Wheeler River Project

Indigenous Engagement
Appendix B Part 3

Denison's Responses to Comment from Ya'Thi Néné Lands and Resource Office (March 4, 2023) for the Wheeler River Project Environmental Impact Statement

Re: Wheeler River Project Environmental Impact Statement - Denison's Response to Woodland
Caribou Habitat Comments

Figure 2. Wildlife detections by treatment type, all species combined (caribou, moose, black bear and wolf). Green/positive indicates desired avoidance of the treated LF; red/negative indicates undesired use of treated LF.

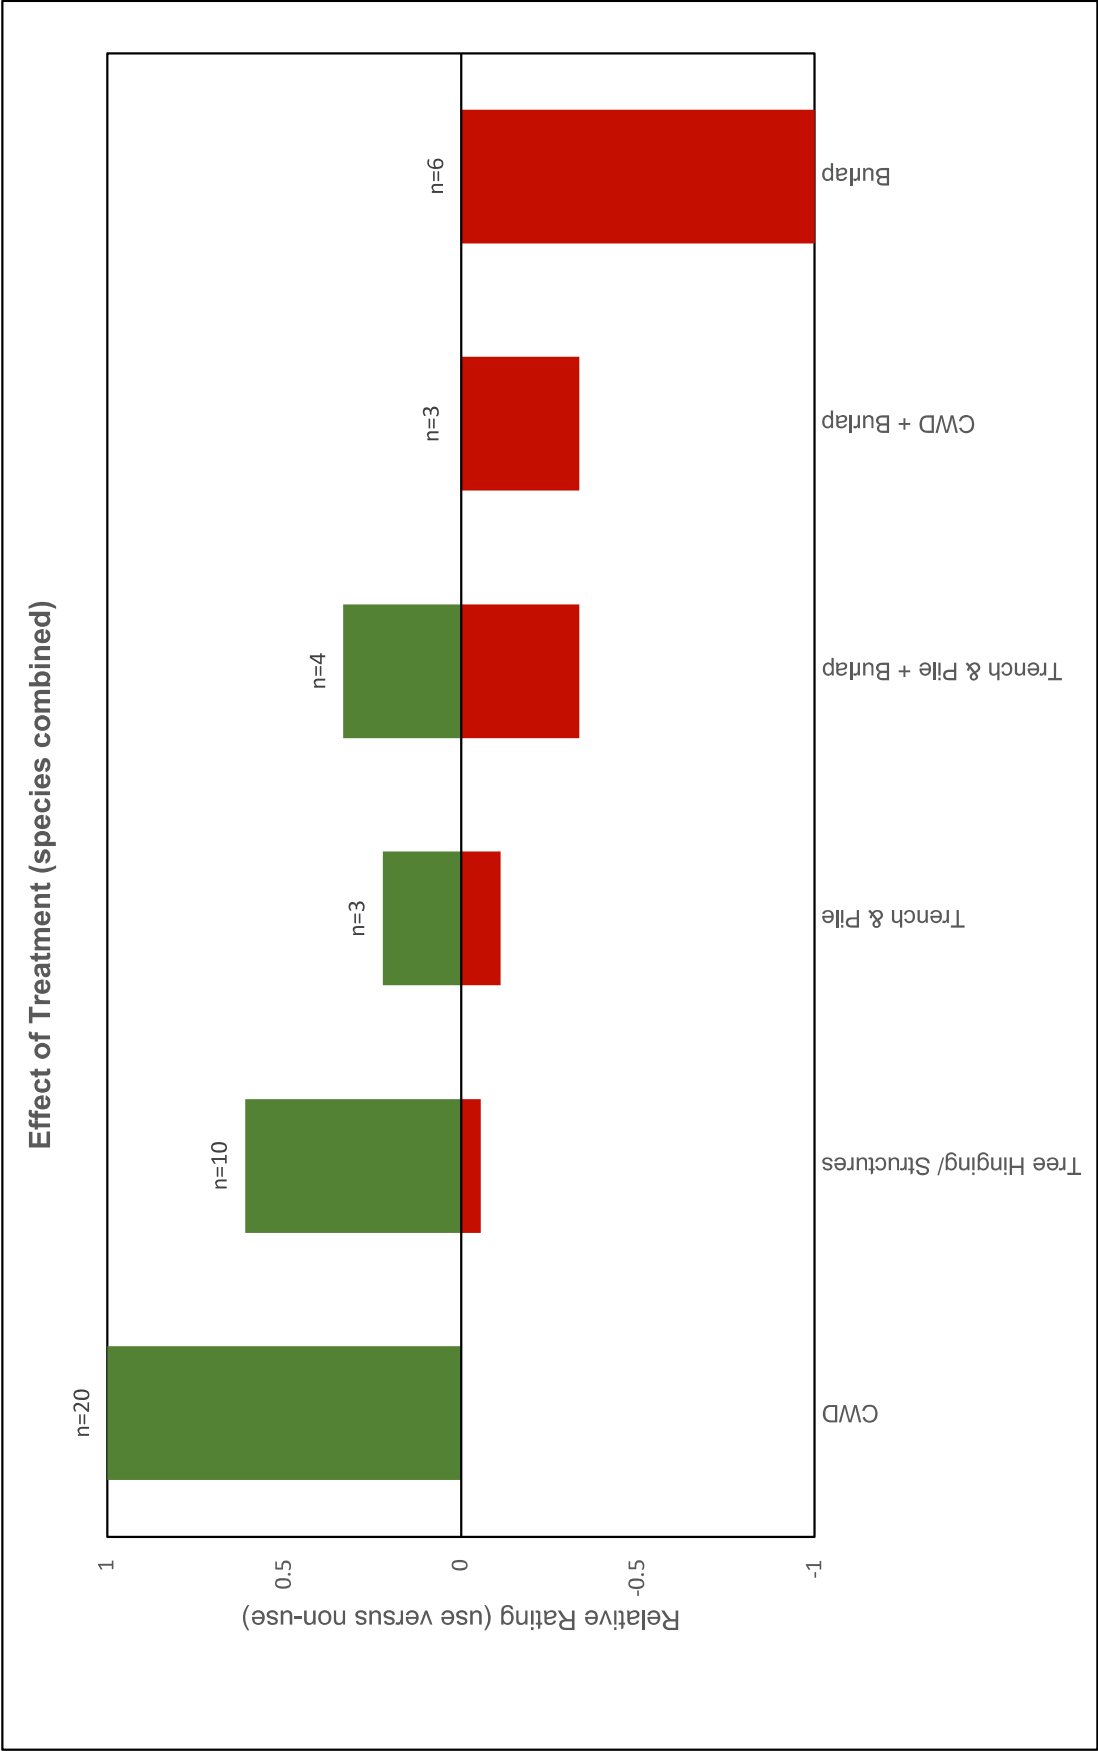
[Figure 2](#) shows the results of the treatments for all species of interest combined. CWD treatment sites had the most wildlife detections (20) of three species, (bear, caribou and moose) and all interactions were positive (non-use of the line). Tree hinging/structures had ten detections of bear and caribou, 92% of these interactions were rated as positive. Trench and pile treatments had three moose detections; two thirds positive. Trench and pile + burlap had a split response between bears (all use) and moose (all non-use). CWD + burlap and burlap only had all negative interactions.

Figure 3. Caribou, moose, black bear and wolf detections by treatment type. Green/positive indicates desired avoidance of the treated LF; red/negative indicates undesired use of treated LF.

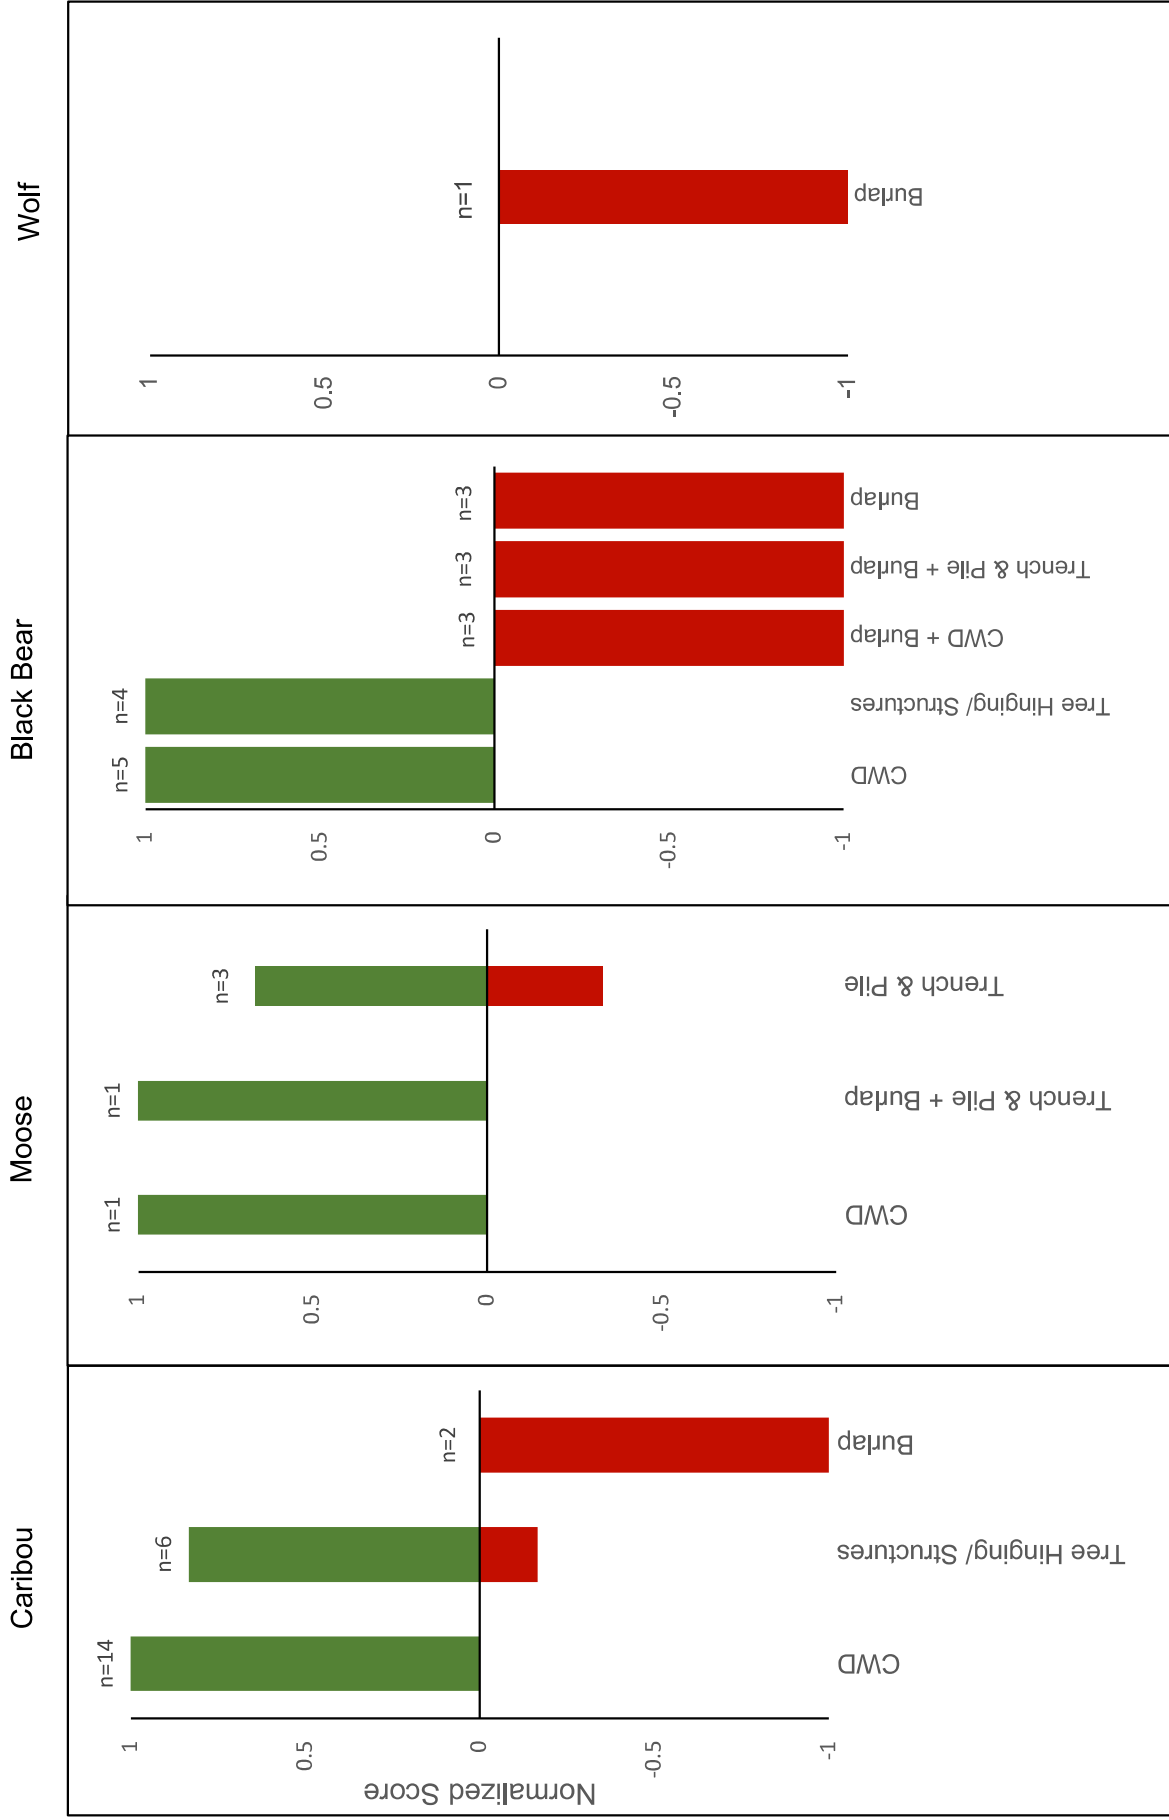
[Figure 3](#) shows the results of the treatments for each species of interest. Caribou showed positive interactions (avoidance) with CWD and tree hinging/structures (100% and 83% of detections, respectively) and a negative interaction with burlap (100% of detections). Moose response to CWD and trench and pile + burlap was 100% positive, and was two-thirds positively associated with trench and pile. Black bears responded positively to CWD and tree hinging/structures, and negatively to CWD + burlap, trench and pile + burlap, and burlap only. Wolf responded negatively to burlap.

Figure 5-1: Proposed Project Footprint (+ 500 m buffer) with Existing Anthropogenic Disturbance (+ 500 m buffer) Visible on Landsat at 1:50,000

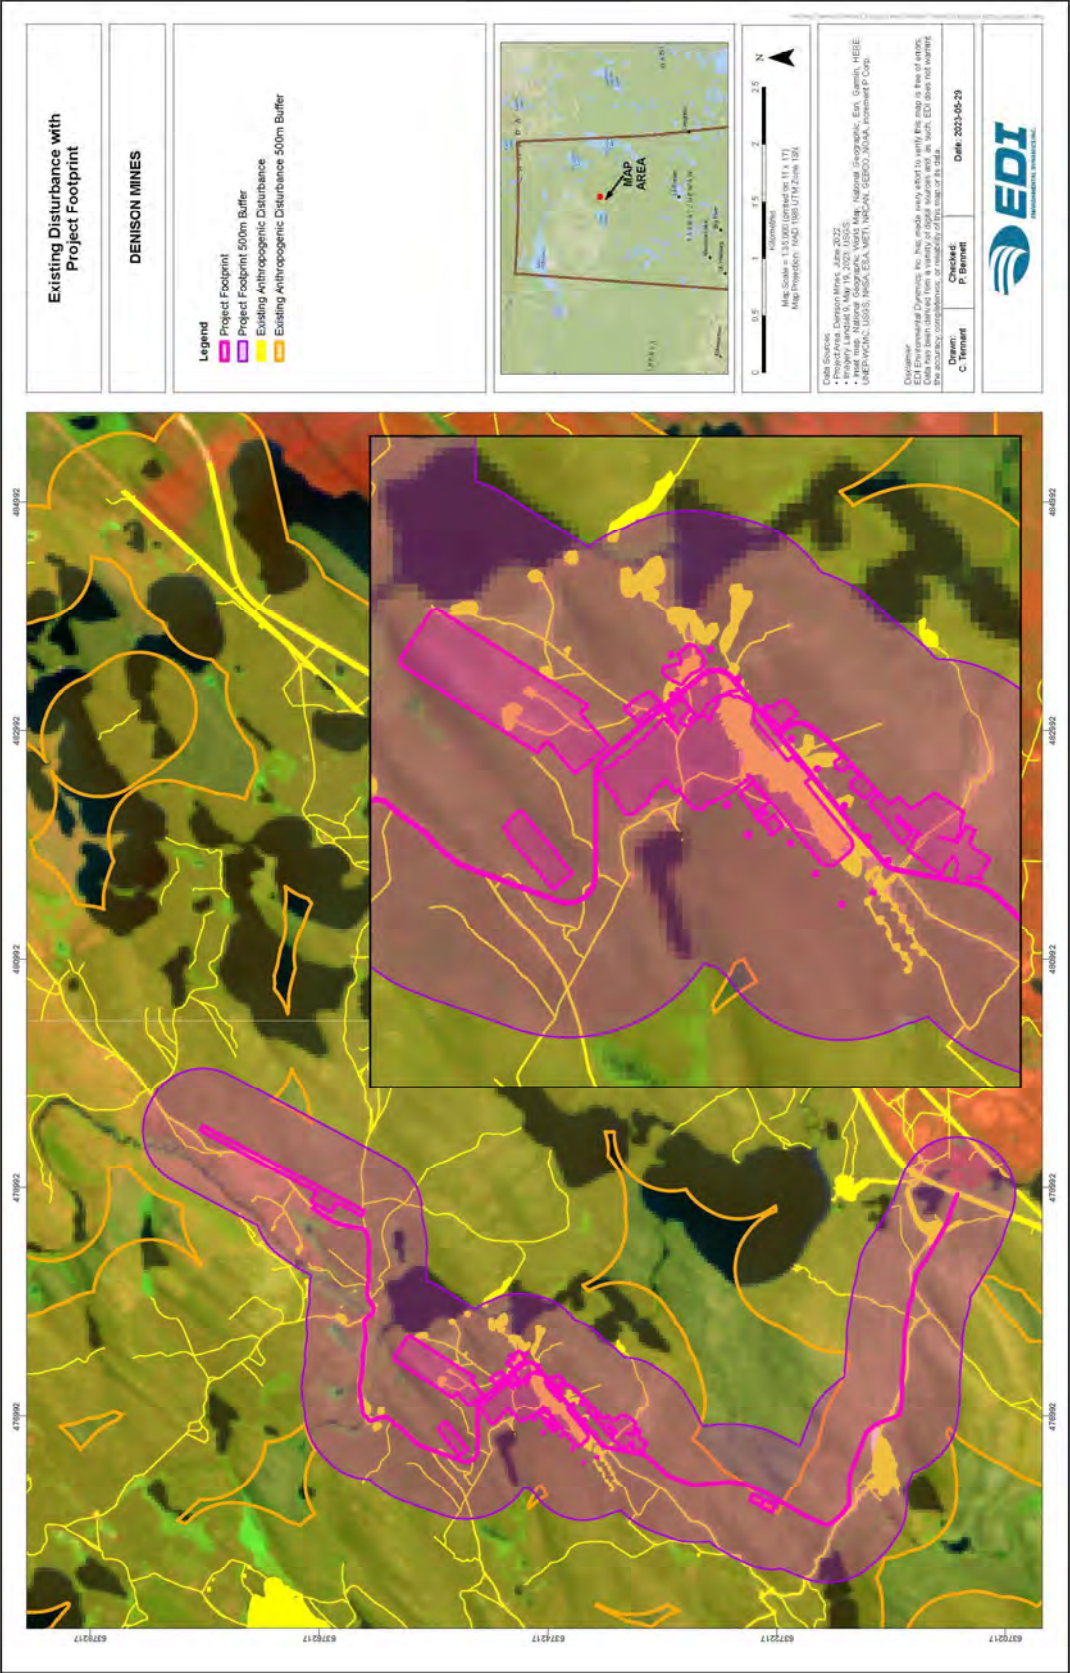
As shown in Table 5-1 and Figure 5-1, the proposed Project footprint + 500 m buffer is almost entirely located within existing, buffered anthropogenic disturbance. This means the Project footprint + 500 m buffer is located within already disturbed habitat, according to ECCC (2020). Additionally, the mapping exercise shows that approximately half of the Project footprint + 500 m buffer is located within regenerating forest, i.e., forest burned less than 40 years ago (Figure 5-2).
